SECTION 23  
T19 S. R41 E. W.M.

Vale Oregon  
Irrigation  
District

HB 3111 Petition			
Page		of	Pages
Digitized By	RJ & LHP	Approved

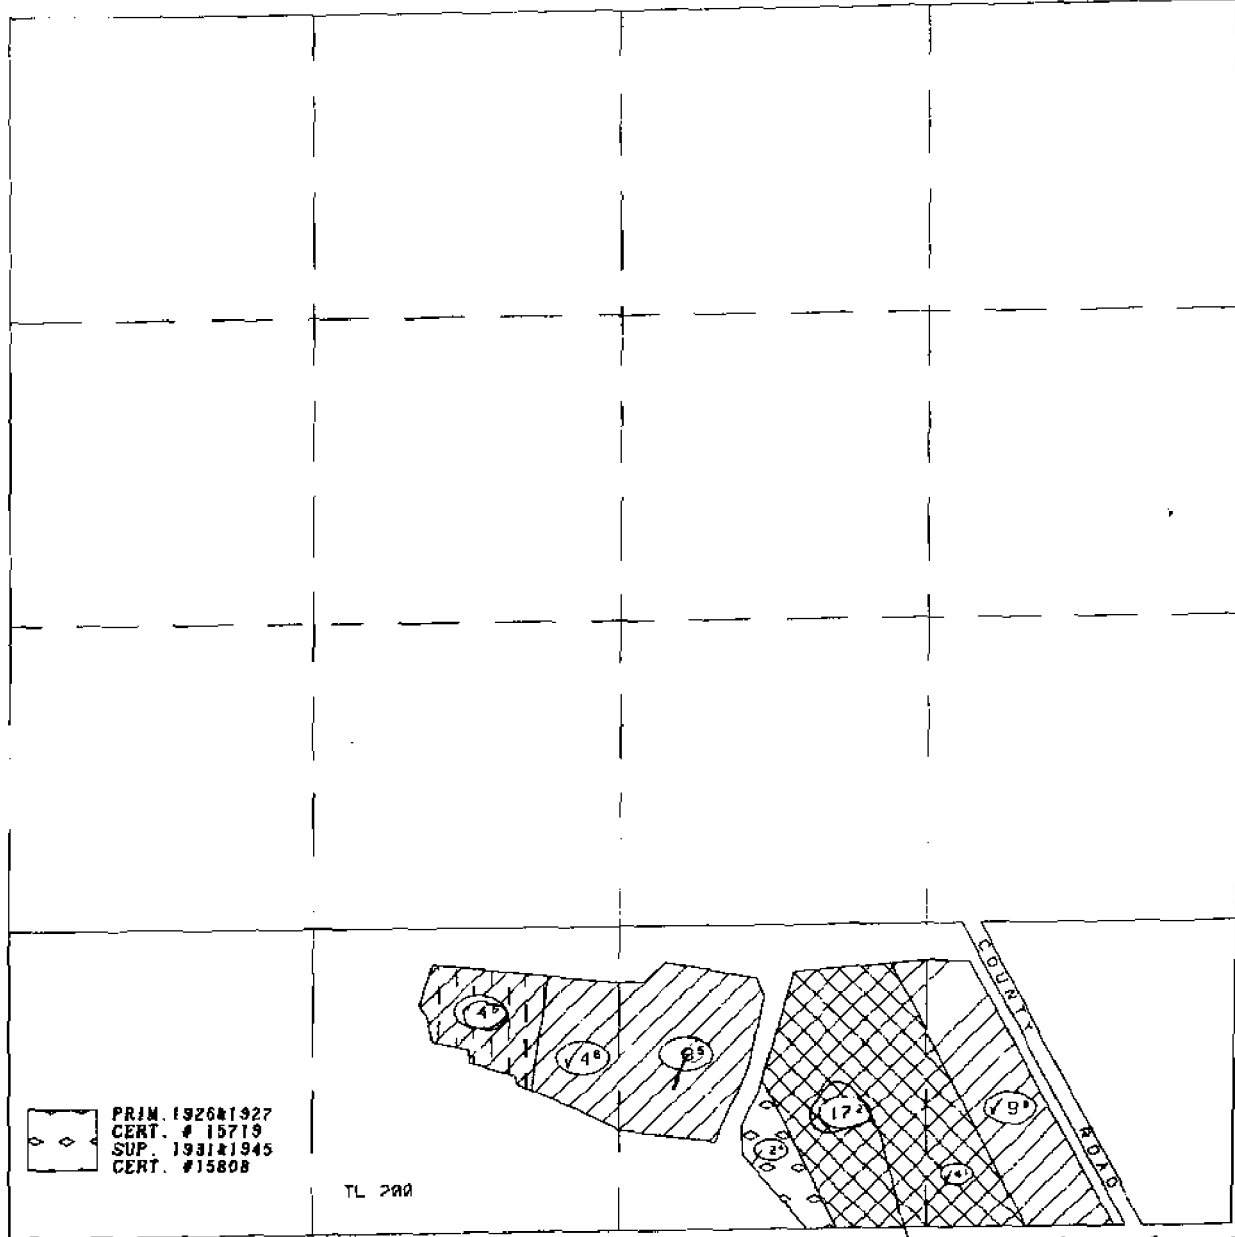
Should this be 14.8 ac?
